Project Name: Winters Industrial Park

Preliminary Plan:

Re: FILE #59-78 PRELIMINARY PLAN, WINTERS AVENUE INDUSTRIAL PARK

Subdivision Wintees Industrial Park

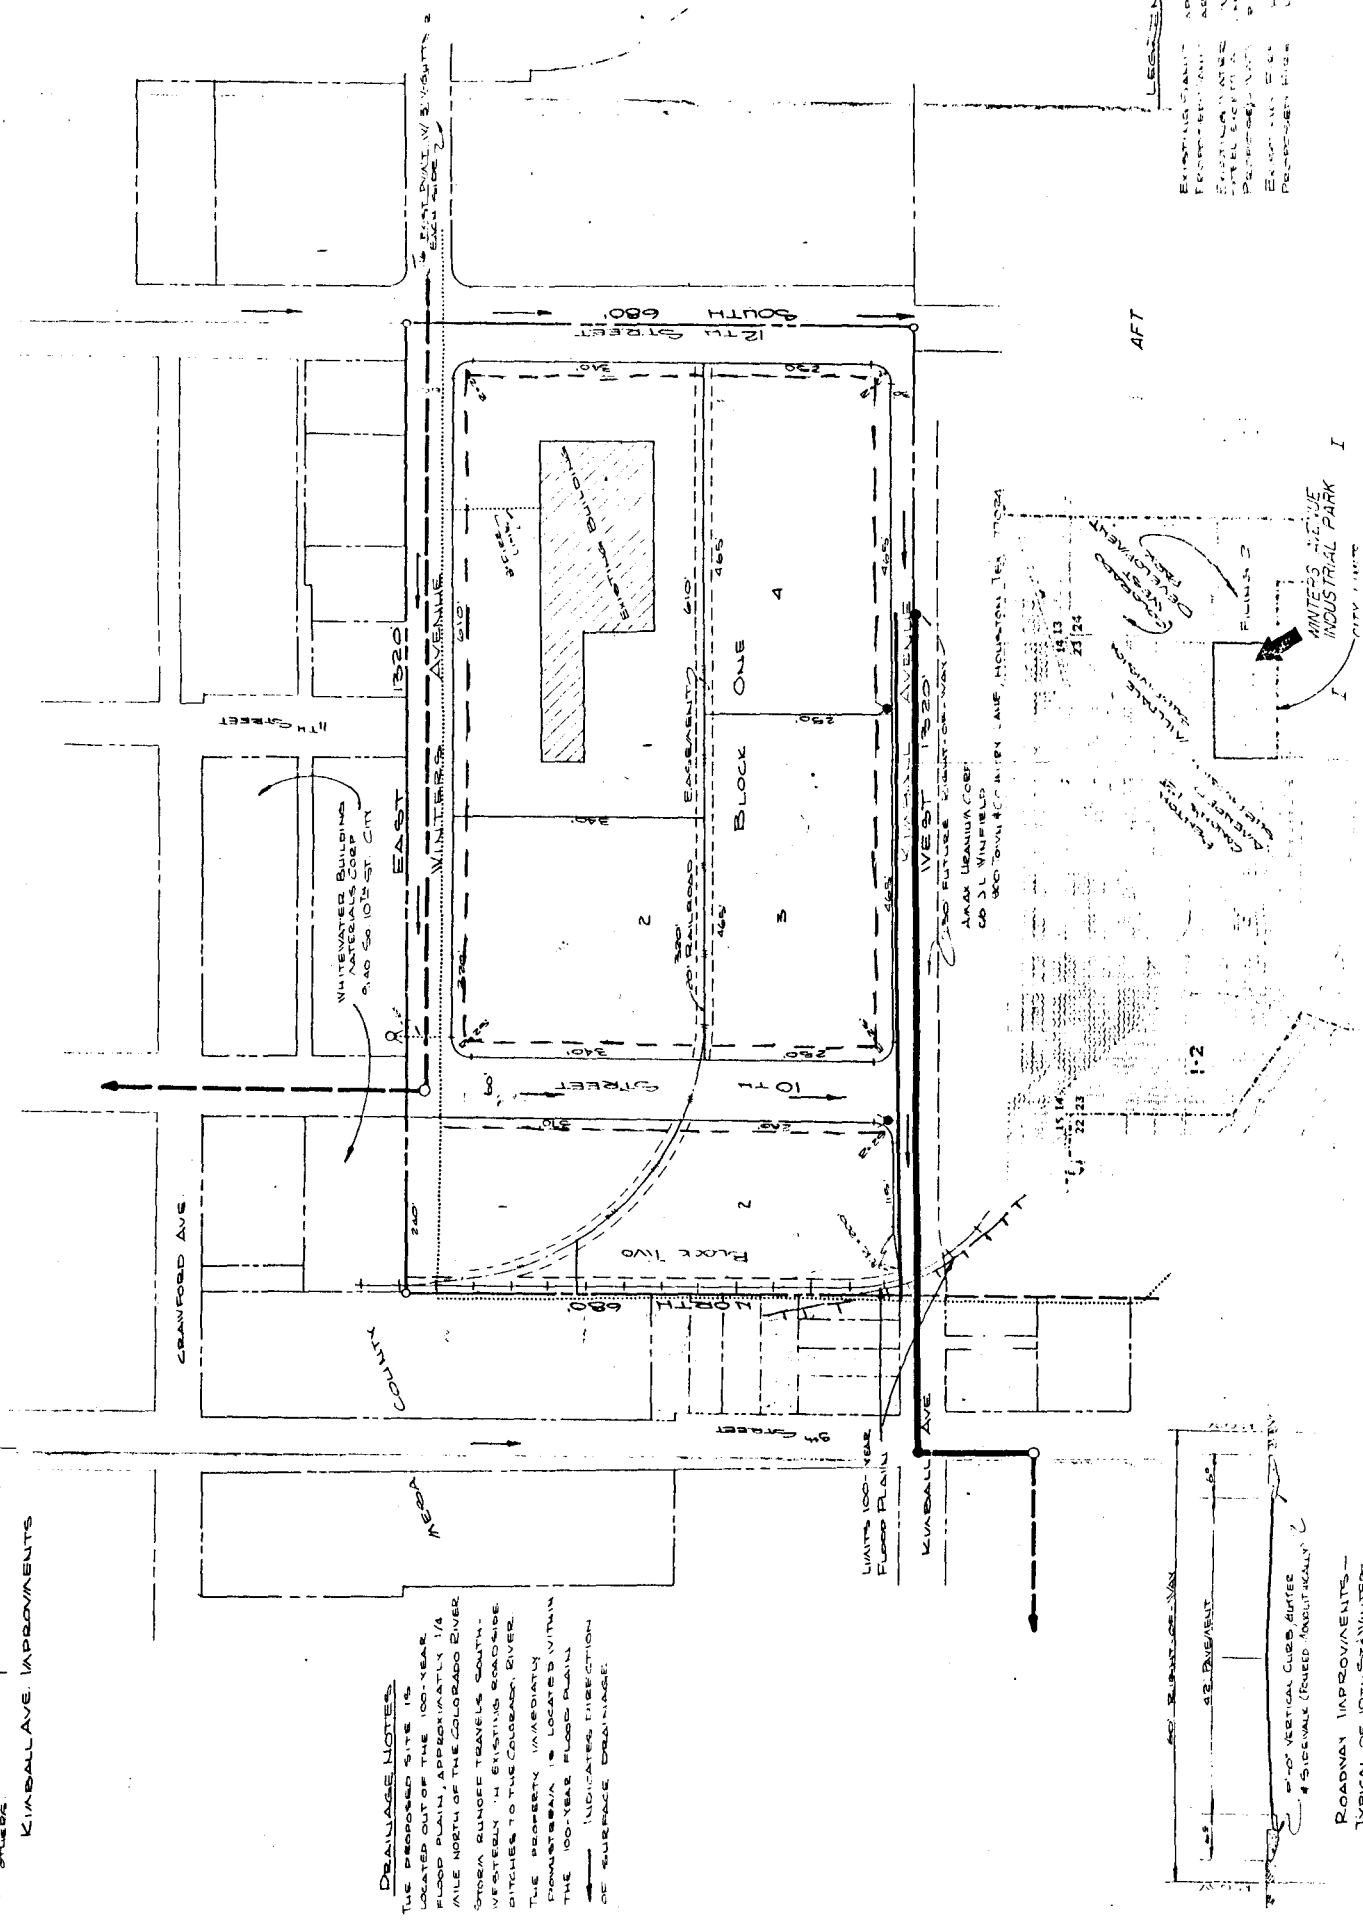
- a) water and sewer line sizes and locations as required by City Utilities engineer.
- b) Easements as required by Mountain Bell and Public Service Company
- c) Tenth Street to be constructed with 41' mat and curb, gutter, and sidewalk.
- d) Twelfth Street to be constructed in conjunction with Colorado West Development Park #2 with 41' mat and Power of Attorney for curb, gutter, and sidewalk.
- e) thirty-foot right-of-way on Kimball with proposed street improvements is acceptable. However, no access to lots from Kimball will be allowed until it is fully dedicated and improved. This will be stated on the recorded plat.
- f) Fire hydrants as required by the City Fire Department.

Utilities - New 12" water main should be extended S. on 12th from existing line on Wintees to Kimball 8" line on Kimball to Hydrant. Sewer line must be upgraded to 7th ST.

Engineering - 10th & Kimball to be improved initially w. 41' mat 6' C, G, & SW both sides on 60' ROW. Match grade to 9th & Kimball.

This proj. in conj. w. Cdo. W. Dev. Pk. #2 to install 41' mat on 12th &

Full cost POA. for C, G, & S.W. Soils are very poor.

P.S. Co. - Requires easements
Fire Dept. - 6 hydrants req'd
MTN Bell - requires add'l easements

Subject to review comments except for Kimball Ave improvements
